## SITE PLAN APPEAL

CASE NO. SP-06-0411C (R1)

PROJECT NAME Colina Vista Duplex

Re: Appeal of November 18, 2008 decision by the Zoning and Platting Commission  
regarding Colina Vista Duplex Development, SP-06-0411(C)(R1) ["Colina  
Vista"]

## SLOPE ADJUSTMENT EXHIBIT PERMITTED TOPOGRAPHY

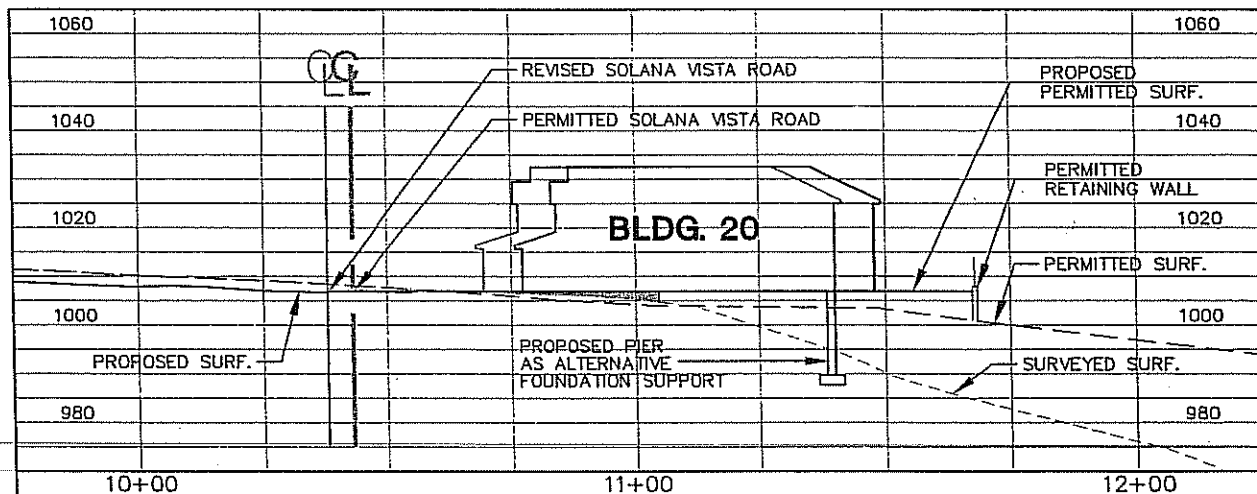
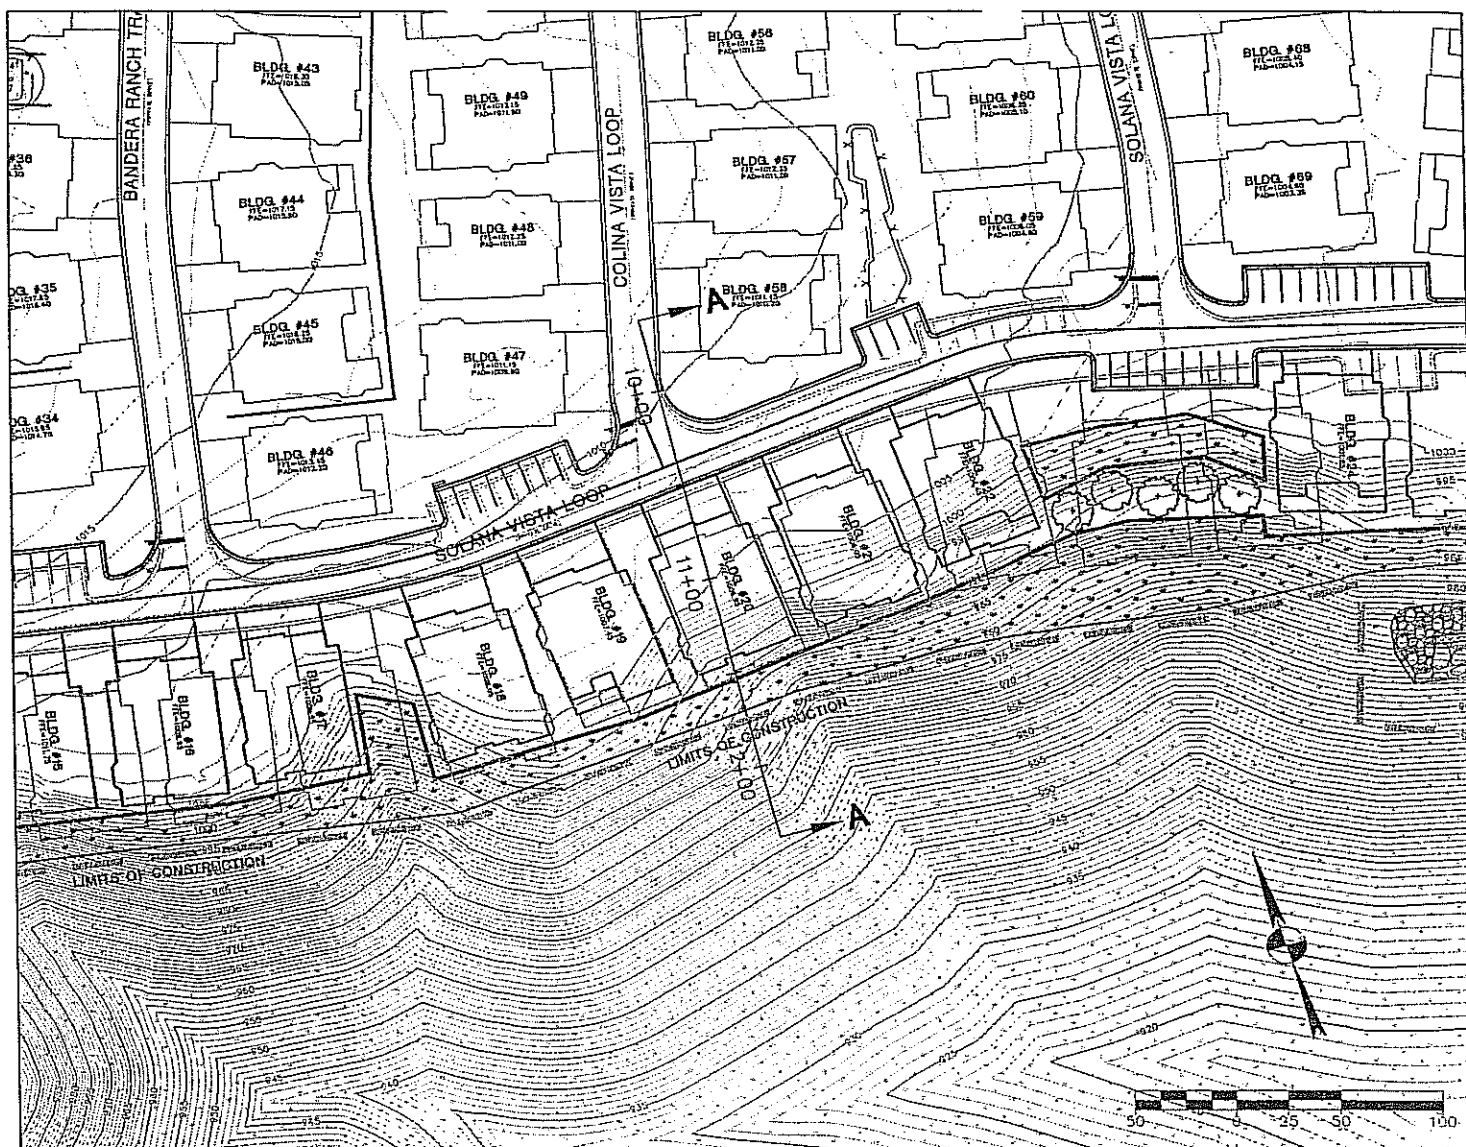
The grading design of the subject site as currently permitted is based upon on-the-ground topography from Carson and Bush Professional Surveyors as well as City of Austin two (2)-foot aerial contours. Working with J.C. Evans Construction during the site clearing process, it was determined that the location of the ravine as depicted on the combined existing topography plan differed from the actual field location. The utilization of City two (2)-foot topography, while accepted under code, did not accurately represent the ravine due in part to the dense tree cover in the area. The bluff line encroaches approximately 20 to 40 feet into the site as compared to the permitted topography. This encroachment affects the foundation of 11 duplex units which overlook the bluff.

In discussions with staff, the applicant has re-aligned the roadway and buildings along this bluff line to minimize construction on slopes over 25%. This has reduced the square footage of buildings on slopes over 25% from 20,061 square feet to 10,752 square feet, a reduction of approximately 53%. Additionally, the approved plan allowed for terracing and the placement of approximately 4,270 cubic yards of fill along the top of this bluff to allow construction of these duplex units. As part of the revision, the applicant is now proposing to construct these duplex units with pier and beam construction, thus eliminating the need for the terracing and fill. This will also greatly reduce the impact to this steep slope. The applicant will use enhanced erosion controls while the project is being constructed which will ensure erosion and sedimentation doesn't impact the Preserve Area. Lastly, the applicant has moved a flow spreader located along this bluff line topographically higher along the bluff line, which also has less impact on the sloped area.

Our proposed solution will utilize a pier and beam foundation method to suspend the home foundation over the existing slope. The homes will maintain their current location on plan.

### SURVEYED TOPOGRAPHY

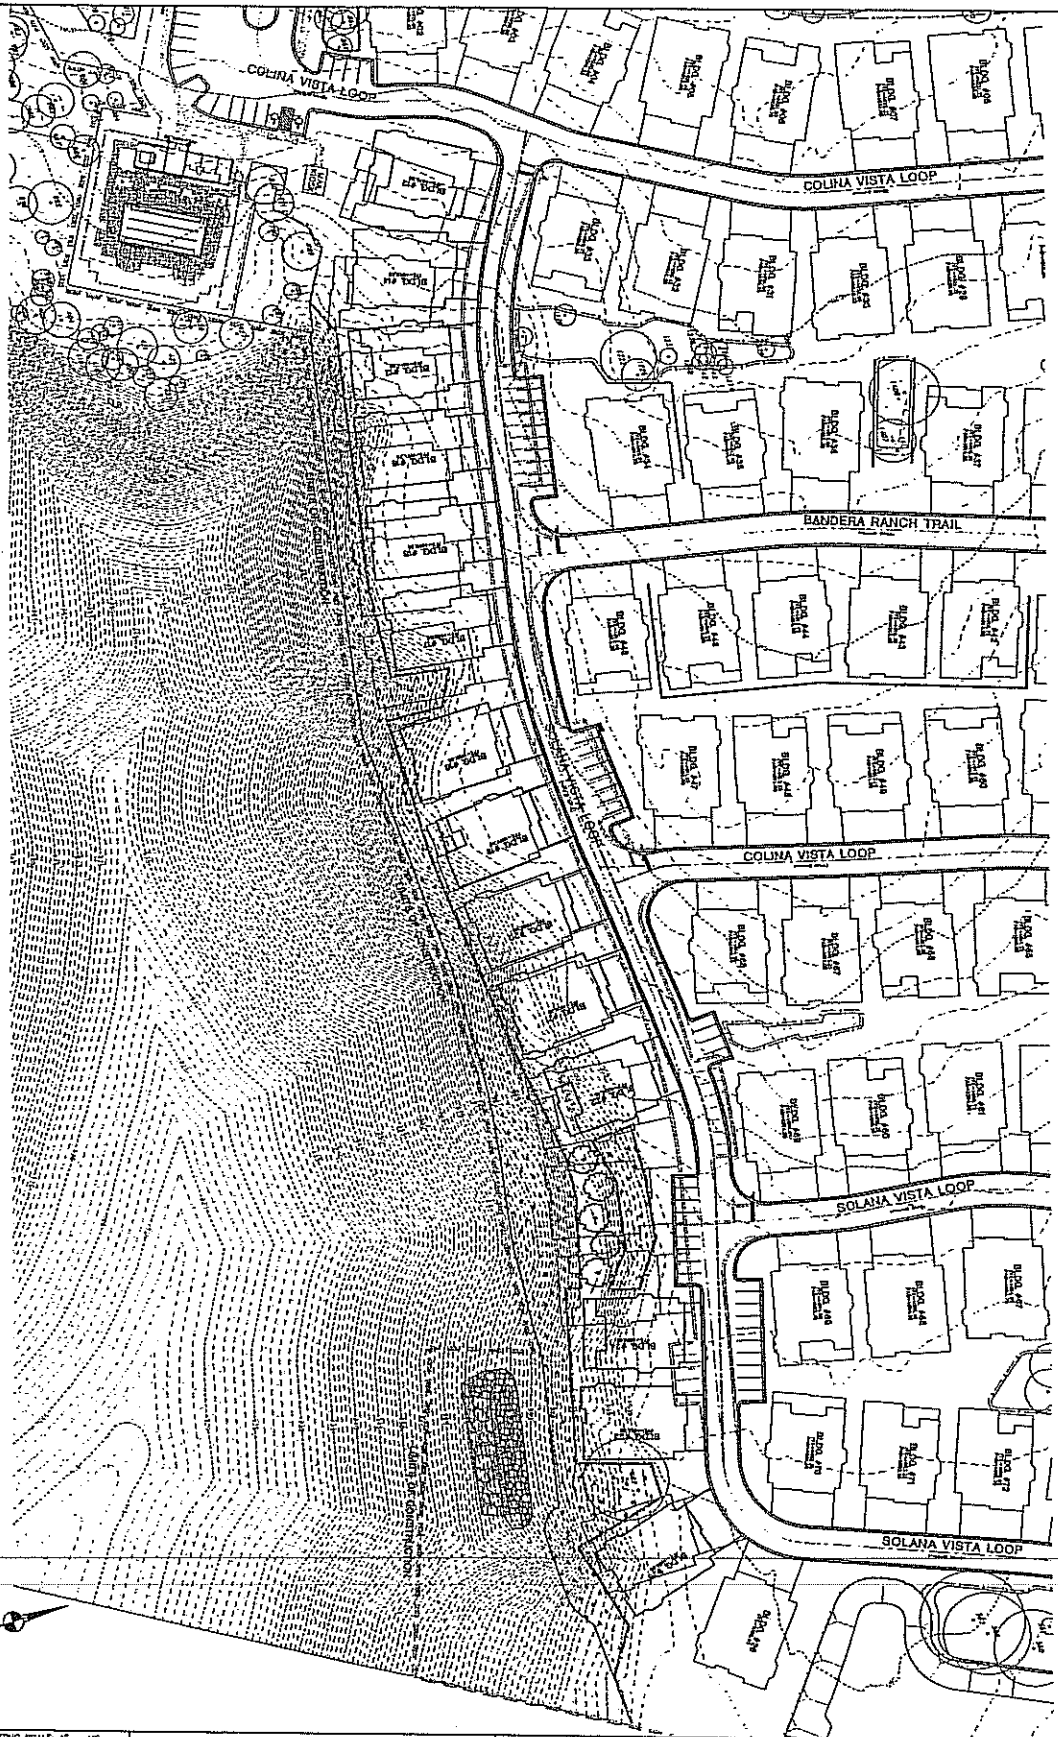
*Yes. Once the permit was issued and the applicant began surveying the site, discrepancies between the City of Austin topography (which is allowed to be used by City Code) and actual surveyed topography appeared. As a result of these discrepancies, when the development was laid out, approximately 11 duplex units located along the southern edge of the development were on slopes greater than 25%. In order to minimize impacts to the slope, and provide better environmental protection, the applicant has re-designed the roadway and duplex units adjacent to this slope to minimize construction on slopes over 25%. In order to further minimize construction on the slope, the applicant has revised the plan to construct the units along this slope with pier and beam construction. Under the approved permit, the applicant was going to build a retaining wall along the edge of this slope to build these units on. This would have required approximately 4,270 cubic yards of fill that would have been placed at the top of this slope and been a major potential source for sedimentation. Lastly, the applicant has moved a flow spreader located on this same slope up topographically from where it was originally approved. This means that the construction of the flow spreader will not impact as much of the slope. In making these revisions*

*Yes. Although these topographic discrepancies have created the need for this variance, the applicant has revised the proposed development to remove as much development on slopes over 25% as much as possible. Initially, there was approximately 20,061 square feet (0.46 acres) of buildings on slopes over 25%. After the applicant's revisions, there now is approximately 10,752 square feet (0.25 acres) of buildings of slopes over 25%, a reduction of approximately 53%. This reclaims approximately 16,390 square feet (0.376 acres) of the natural slope back from the approved and permitted version of the plan.*
